Kensington Parkwood Elementary School Addition, Mandatory Referral No. MR2016013

Description

Summary

Figure 3: Proposed Site Plan

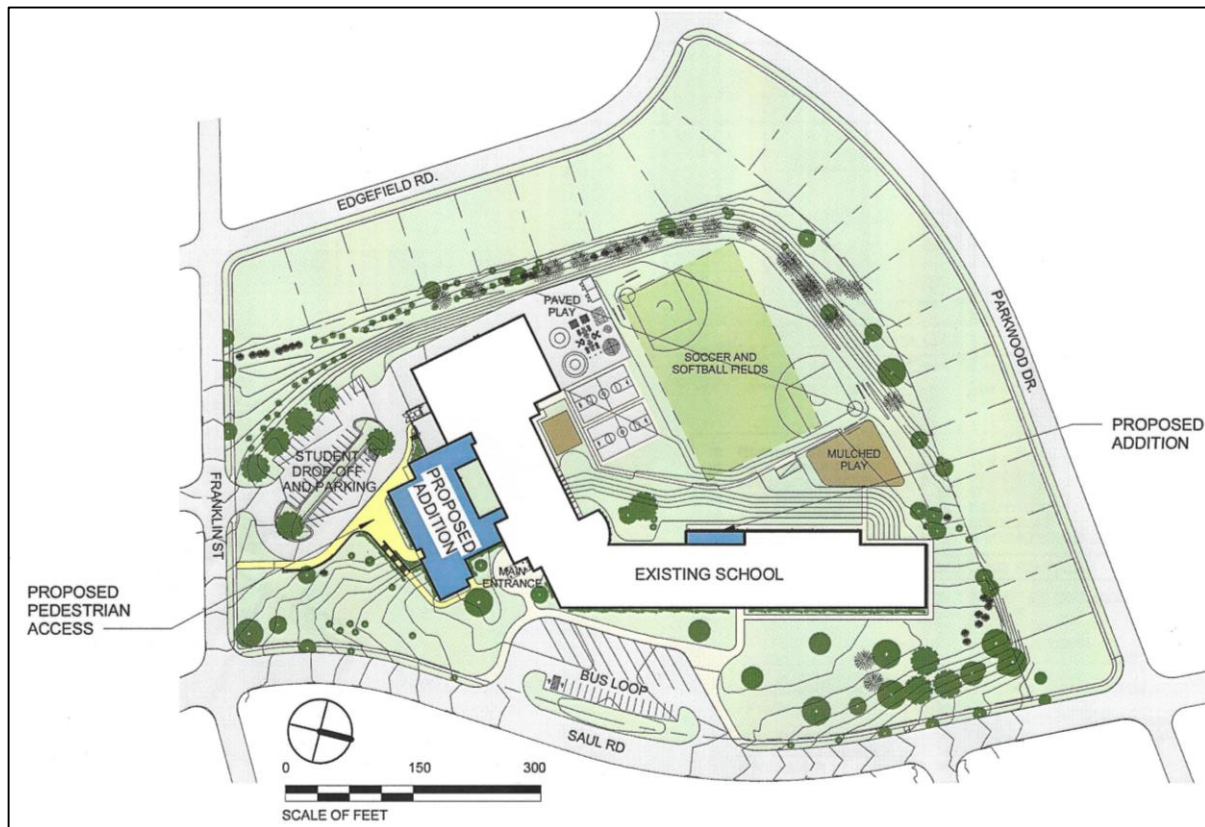
Vehicular circulation will not be altered and will remain adequate, safe and efficient. Curb cuts onto the Site are minimized to provide safe pedestrian circulation. Separation of the bus and parent drop-offs and pick-up improves the efficiency of circulation accessing the Site. However, the Applicant has indicated that queuing space in the parent drop-off/pick-up area is currently maxed out. To enhance vehicular circulation, Staff recommends MCPS implement appropriate measures to prevent queuing overflow onto surrounding roads.

Although the proposed project includes certain pedestrian and bicycle improvements, it lacks the following improvements which Staff recommends:

1. Upgrading the existing substandard four-foot sidewalks along Saul Road and Franklin Street to the standard five-foot width with a tree panel along the curb per the current Road Code standard.
2. Inverted-U bike racks (or equivalent) at the main building entrances and appropriate location(s) to serve the non-school users of play fields.

The number of on-site parking spaces will increase from the existing 50 to a total of 60 spaces. The Applicant believes that the modest increase in parking spaces will be adequate to accommodate the additional staff. Staff recommends the Applicant monitor the on-site parking capacity and implement measures, as needed, to prevent parking overflow of vehicles onto the adjacent streets.
